APPLICATION NO.	FILING DATE	FIRST NAMED INVENTOR	ATTORNEY DOCKET NO.	CONFIRMATION NO.
10/581,612	06/05/2006	Satoshi Mogi	03500.103465.	5482

Office Action Summary	Application No. 10/581,612	Applicant(s) MOGI ET AL.	
	Examiner Tony Chuo	Art Unit 1795

DETAILED ACTION

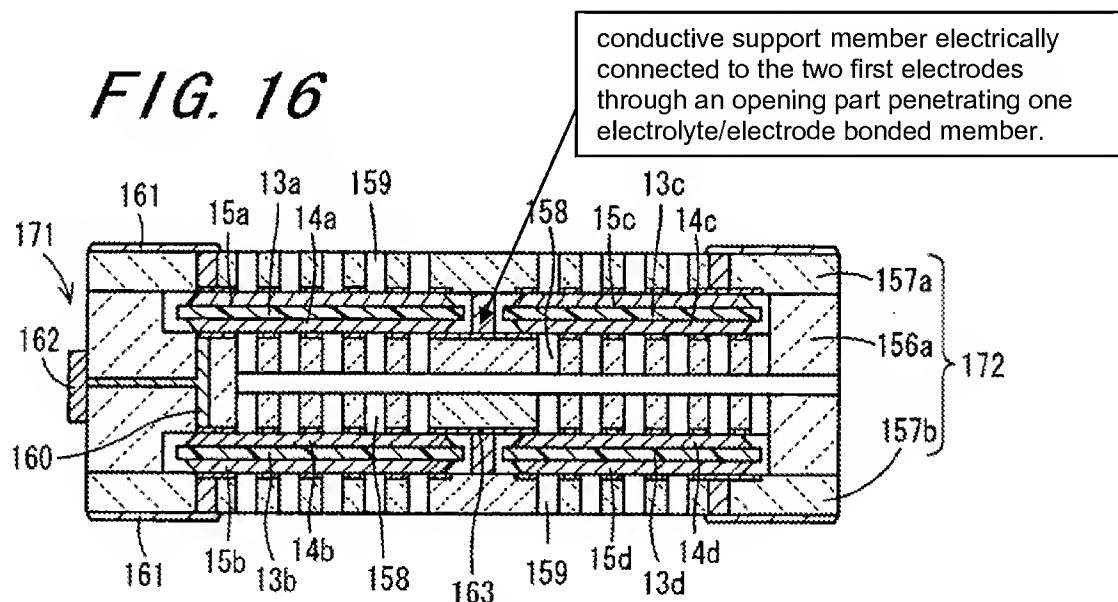
The Sugai reference teaches a conductive support member (see Figure 16 below) that is electrically connected to the two first electrodes "14a" & "14b" through an opening part provided penetrating one electrolyte/electrode bonded member; a second electrode "14a" of a first membrane electrode assembly and a second structural electrode "14b" of an adjacent second membrane electrode assembly that are stacked

so as to face each other via an insulating sealing material "156a", and an conductive support member "164" connected to a first electrode "14a" of a first membrane electrode assembly and a second electrode "15b" of an adjacent second membrane electrode assembly that are electrically connected, whereby the first membrane electrode assembly and the second membrane electrode assembly are connected in series (See Figures 16 and 17).
